UNITED STATES
DEPARTMENT OF THE INTERIOR
BUREAU OF LAND MANAGEMENT

SUNDRY NOTICES AND REPORTS ON WELLS
Do not use this form for proposals to drill or to re-enter an abandoned well. Use form 3160-3 (APD) for such proposals.

8. Well Name and No.
EAST BLINEBRY DRINKARD UNIT 22

Apache proposes the attached conformance procedure and WBD's to workover this injection well. (EBDU Waterflood Project Case 13503 R-12394)

Well Name: EBDU 22W

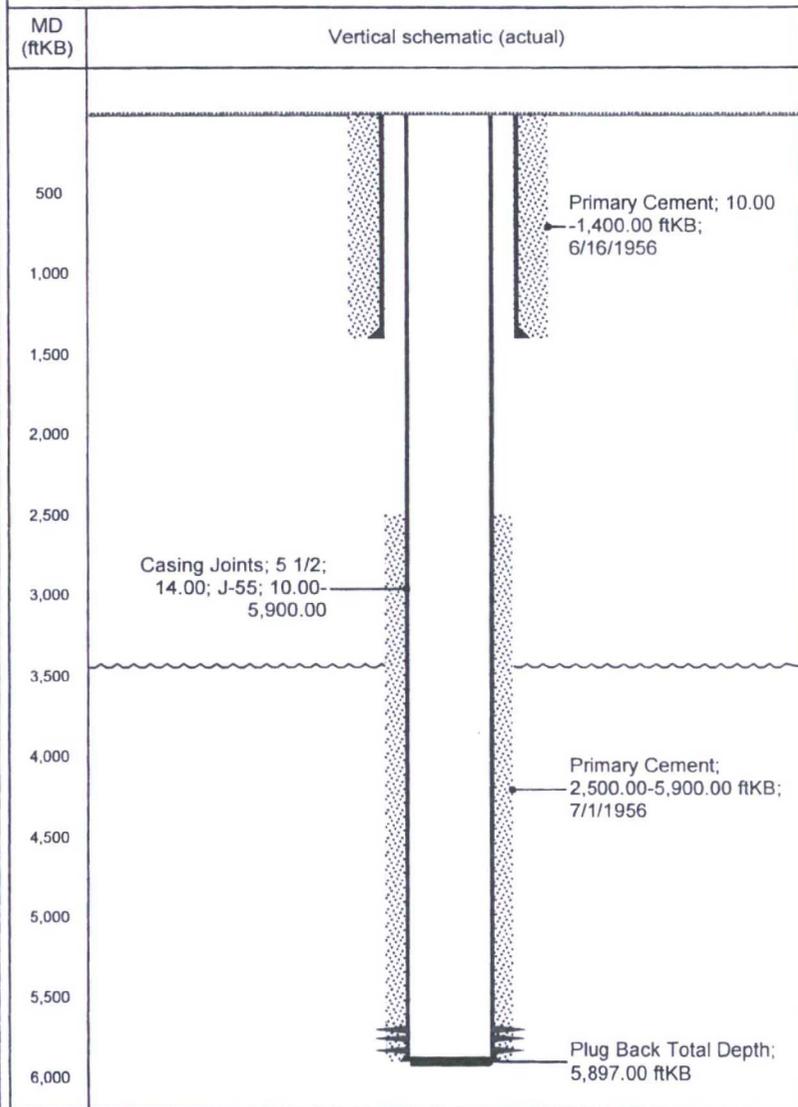
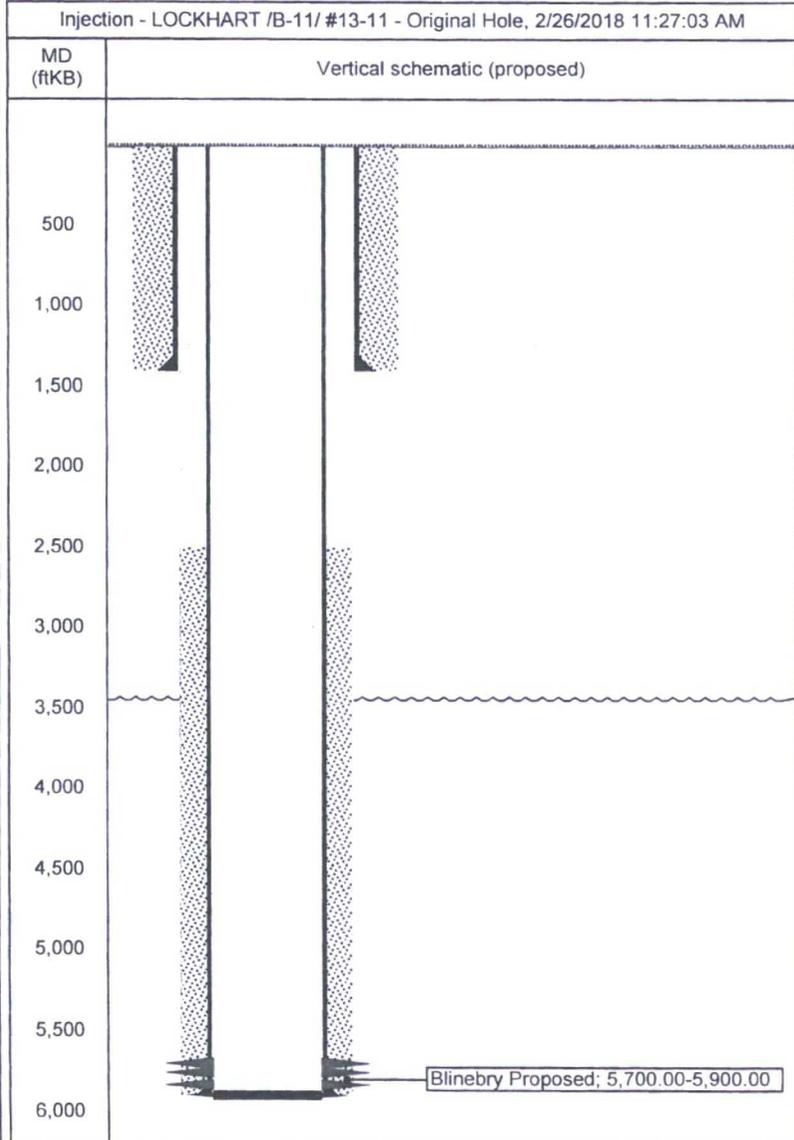
Remedial work needs to be done on 5 ½" casing in order to bring cement to surface.

1. Notify BLM 575-361-2822 before plug back procedures. The procedures are to be witnessed.
2. Surface disturbance beyond the existing pad must have prior approval.
3. Casing added or replaced requires a prior notice of intent (BLM Form 3160-5) approval of the design.
4. Closed loop system required. 2000 2M BOP to be used. All blowout preventer (BOP) and related equipment (BOPE) shall comply with reasonable well control requirements. A two ram system with a blind ram and a pipe ram designed for the work string shall be adequate. Tapered work strings will require an additional pipe ram.
